Flight Procedures Cover Page	Task Action: FLIGHT CHECK	Task Type: IAP	Estimated Chart Date: 03/19/2026	APWS Task ID: 741B00E3A5204C09A8E20A75EEC2128F	APWS Project ID: 74166A518FF948E5AFF907A25152E9CE
Procedure: ILS OR LOC RWY 16R AMDT 2		Enroute: NO	Specialist: Dumar, Ralph	Agreement Number:	
Airport ID: KDEN			Airport City: DENVER	State: CO	
Facility ID:	Facility Type:	Flight Inspection Remark Type: Hold FC Slot

Denver, CO
Denver International, KDEN
ILS OR LOC RWY 16R

Date: 08/15/2025
To: Wade Terrell, Manager, Flight Technologies and Procedures Division THRU:
Wayne Radicke, Manager, Flight Procedures and Airspace Group
From: Julie Morgan, Manager, Team 1, AJV-A41
Subject: Approval Request: DENVER INTL (KDEN), ILS OR LOC RWY 16R

ILS or LOC RWY 16R

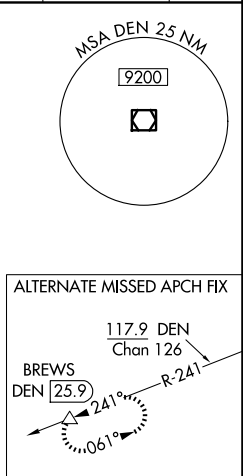
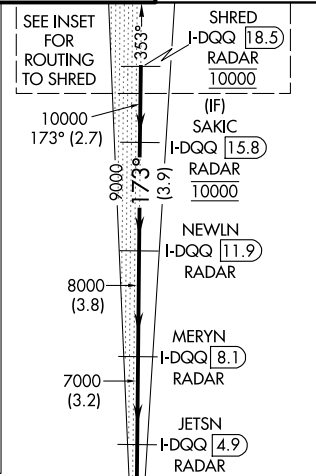
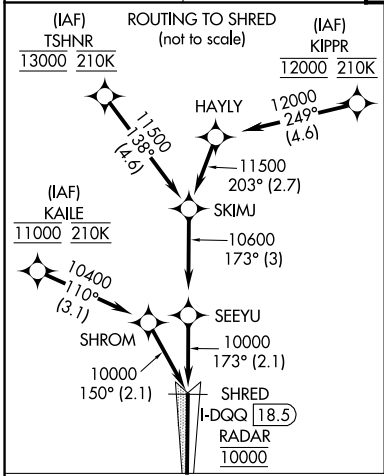
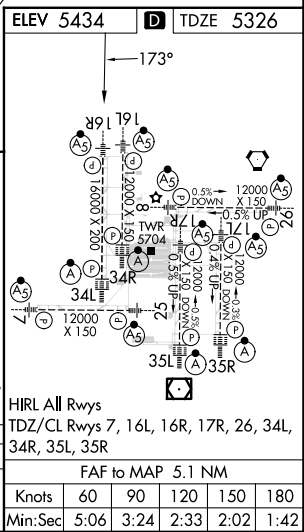
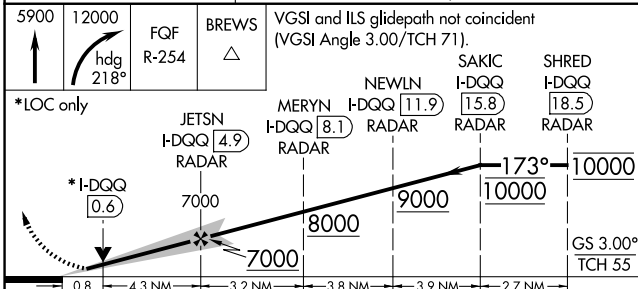
8260-1: INITIAL SEGMENT KAILE TO SHROM: ATC VECTOR LEG LENGTH ISSUES; VECTOR ANGLE RESTRICTED AT KAILE TO 45 DEGREES.

APPROVAL LETTER: MANDATORY ALTITUDE AT IF SAKIC.

REMARKS: NEW MISSED APPROACH

Request to publish the ILS OR LOC RWY 16R using the leg length from KAILE to SHROM of 3.02 NM versus the requirement of at least 3.84 NM to support ATC vectors. In order to maintain the current arrival rates at KDEN, ATC has stated their need to be able to vector aircraft to this fix.

ISSUE: MANDATORY ALTITUDE RESTRICTION: INTERMEDIATE SEGMENT SAKIC TO
NEWLN

The intermediate segment for the ILS OR LOC RWY 16R SAKIC to NEWLN has a mandatory altitude of 10000 MSL AT SAKIC.

The prohibition against vectoring to KAILE (in excess of 45°) for this procedure will be included in the facilities Standard Operation Policy (SOP) which will be effective on the publication date of this procedure amendment. ATC will be limited to vectoring to headings 248.07°T (240.07°M) CW 338.07°T (330.07°M). By reducing the intercept angle, the published leg length meets criteria requirements for ATC Vectors.

Request approval to continue to publish the mandatory altitude restriction at the intermediate fix SAKIC.
